Riverside Energy Park

Statement of Common Ground: Environment Agency (Signed)

8.01.11

Statement of Common Ground between the Applicant and The Environment Agency

Date	13.05.19
A1 Scale	1:250
Drawn by	AG
Checked by	PC
Drawing Number	VAA-WA-50080101_1.0

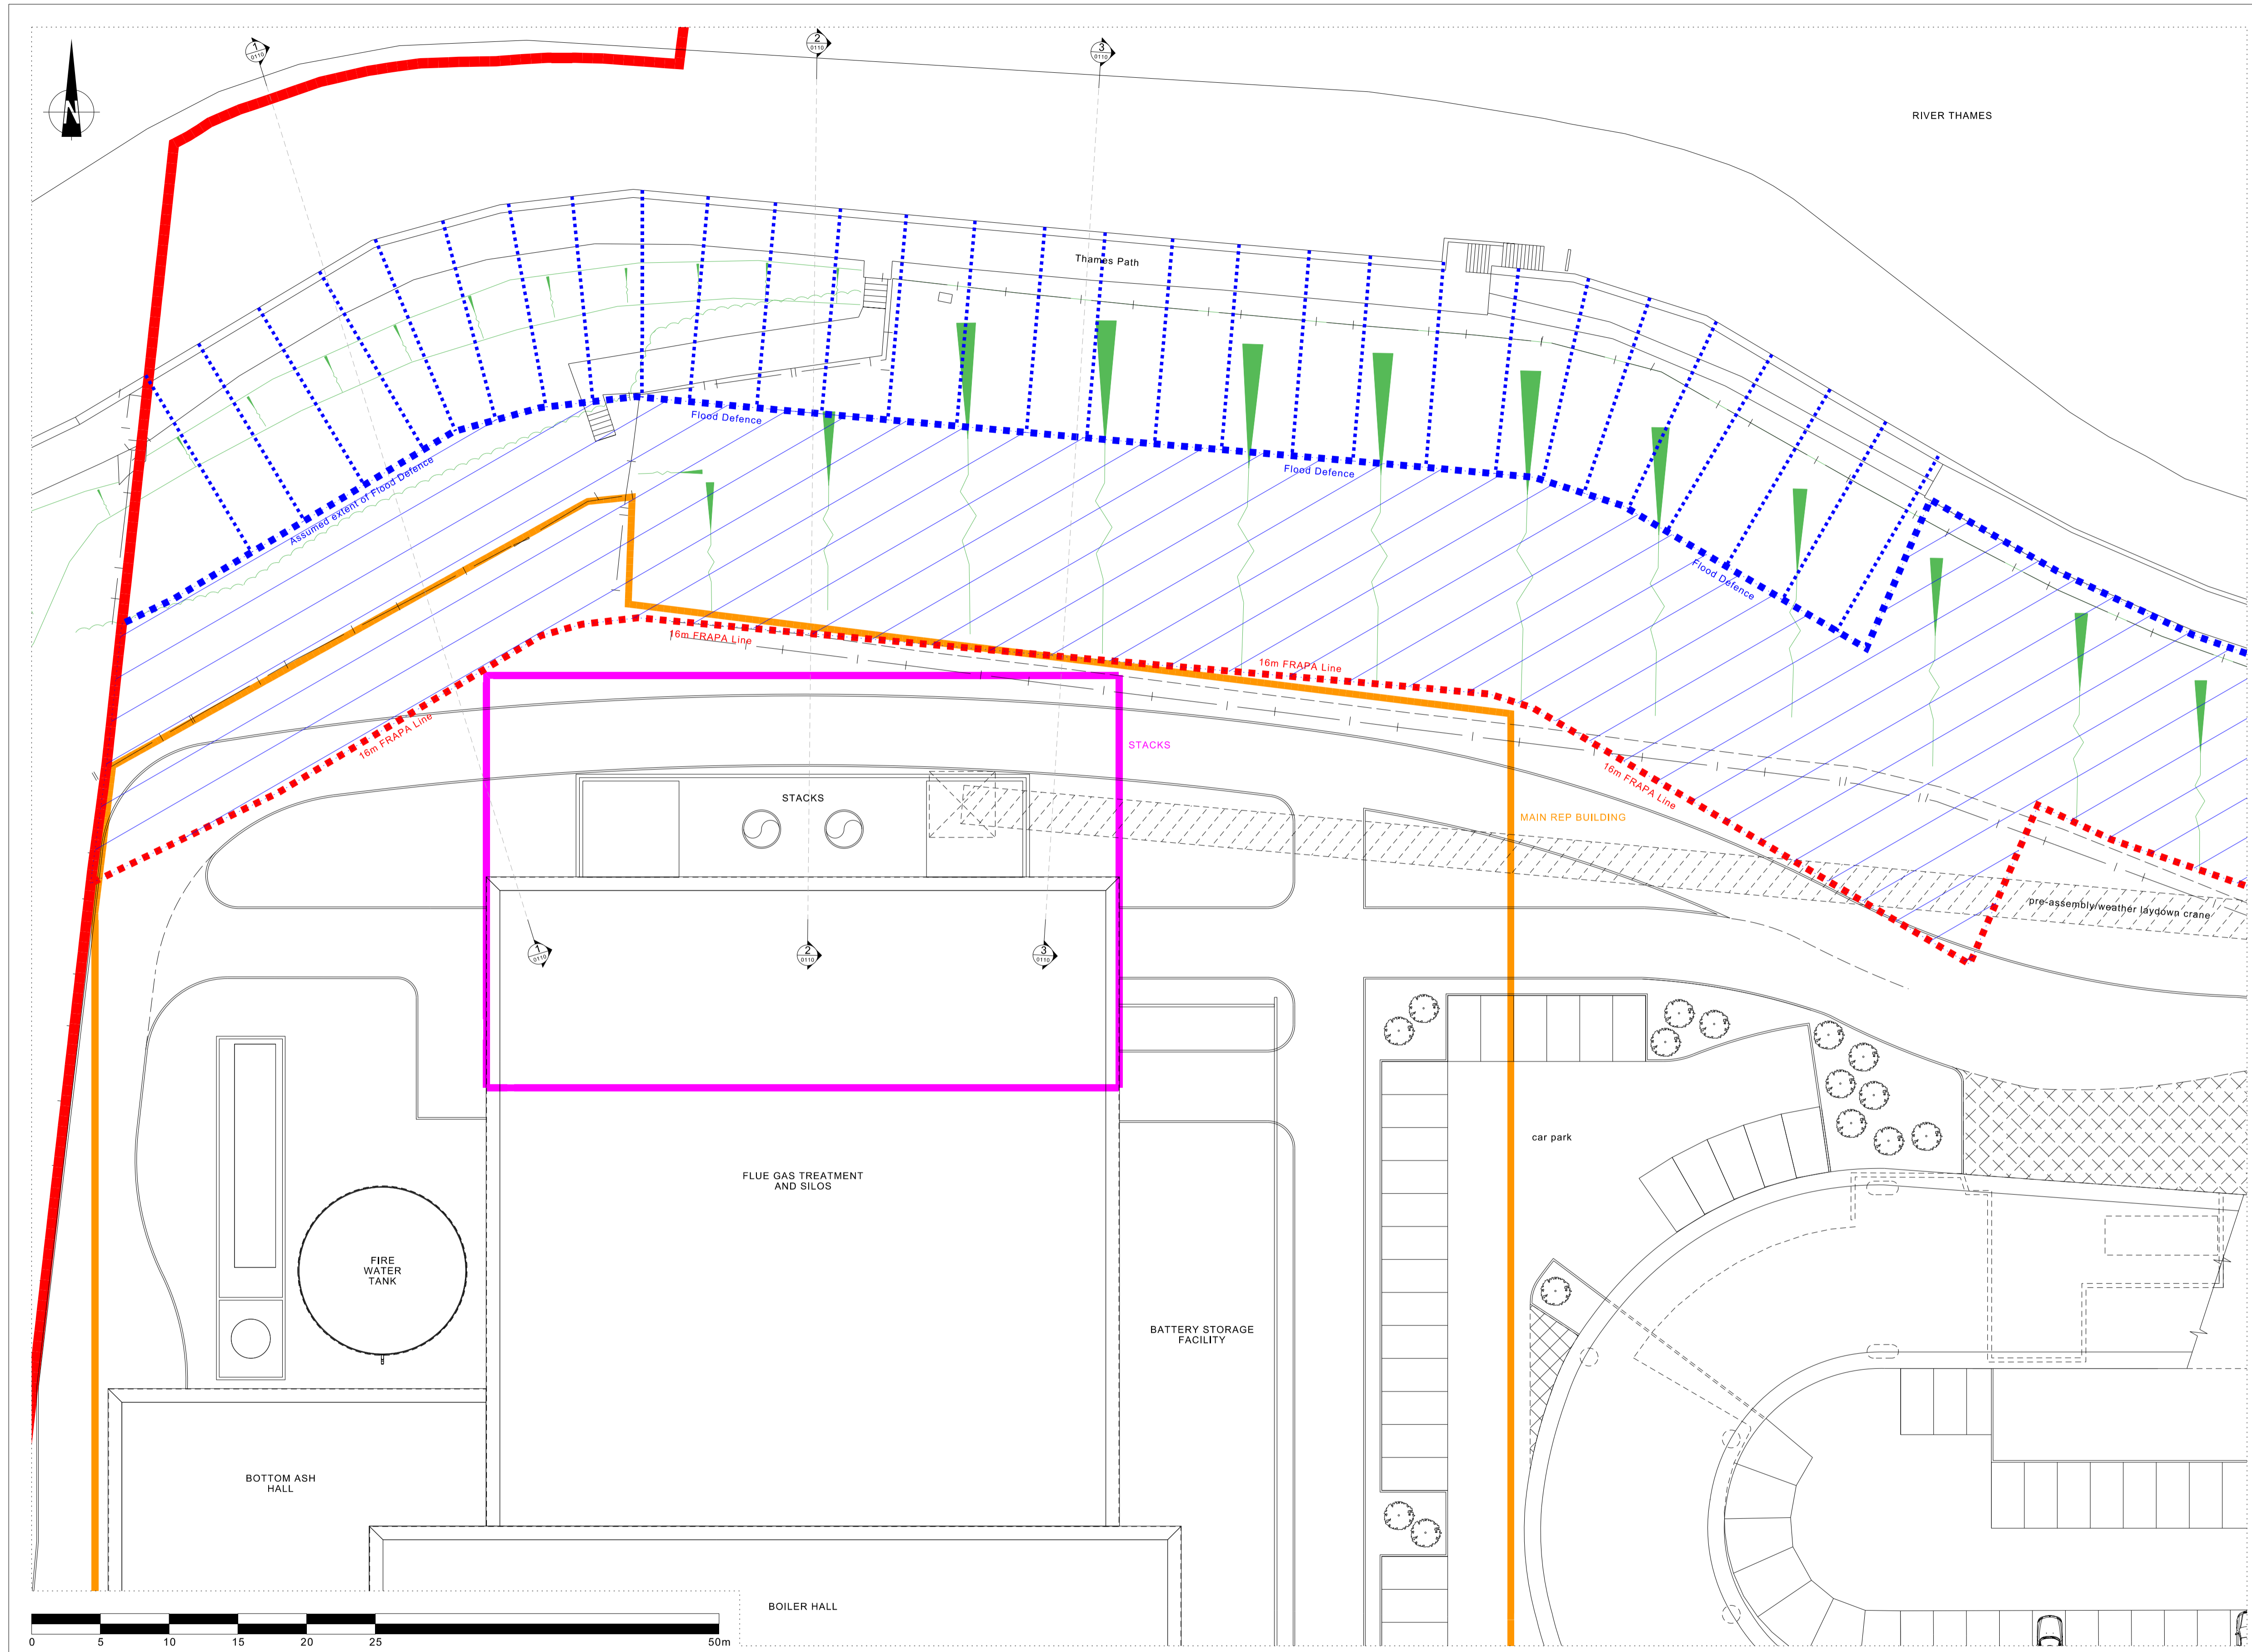
2.3.1 The Flood Risk Activity Permit Area (FRAPA) for REP is shown in diagram VAA-WA-50080100_1.0, VAA-WA-50080110_1.0 and VAA-WA-50080101_1.0 appended to this SOCG (see **Appendix B**).

2.3.4 During operation of REP, activities within the FRAPA are anticipated to include a service road (as indicated in diagram VAA-WA-50080101_1.0). The Parties agree that no buildings (as defined within the **dDCO (3.1, Rev 3)** as "...includes any structure or erection or any part of a building, structure or erection") will be placed within the Flood Risk Activity Area.

No buildings shall be erected within the area defined by the red dotted line annotated as '16m FRAP Line' on Weedon Architects drawing 'DCO Boundaries and FRAP Area Indicative Building Layout' number VAA-WA-50080101_1.0 dated 23.03.19. In addition no material shall be stored, within the area defined by the red dotted line annotated as '16m FRAP Line' on Weedon Architects drawing 'DCO Boundaries and FRAP Area Indicative Building Layout' number VAA-WA-50080101_1.0 dated 23.03.19, which could create a risk of damage to the integrity of the flood defence structure within this area.
